Golden Eagle

Park Dam

ADDENDUM NO. 1

Title: Golden Eagle Park Dam Modifications

EXHIBIT A

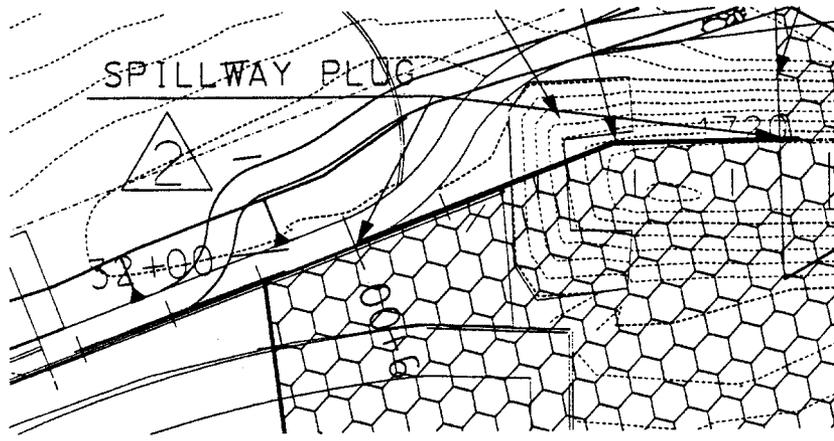
3. Drawing C4, Sheet 10 of 36:
See attached exhibit A.
Sidewalk alignment is changed.
Change Item 12 to read, "CONSTRUCT 6' WIDE SIDEWALK PER MAG 230 (MOD), 1950 SF".

GATE DETAIL

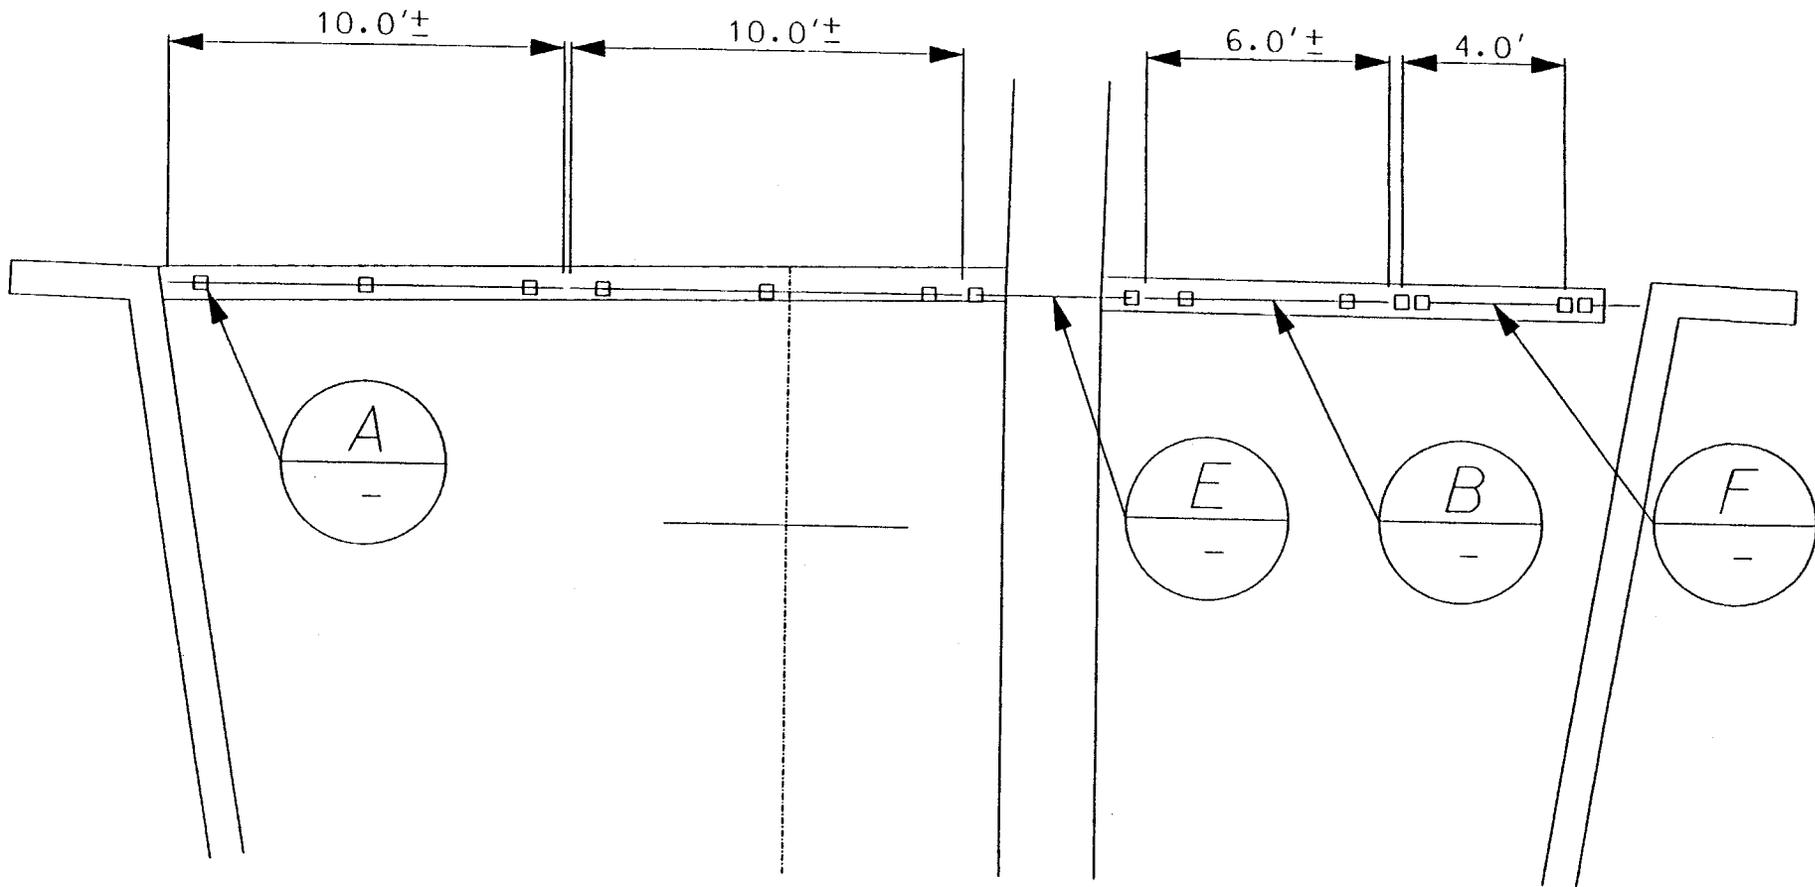
7. Drawing D7, Sheet 20 of 36:
Make the following revisions to the Alternative Access Road Typical Section - Existing Conditions:
Change the callout on the lower right to read as follows: "USE EXISTING SIDEWALK FOR ALTERNATE ACCESS" The arrow should point to the sidewalk.
Cross out the words "FROM EXISTING WASH" from note 4.
8. Drawing D12, Sheet 25 of 36:
See attached exhibits B and C.
Added weepholes to the concrete floodwall.
9. Drawing D14, Sheet 27 of 36:
See attached exhibits D, E and F.
Added Gate Detail and revised the length of the breakaway panels.
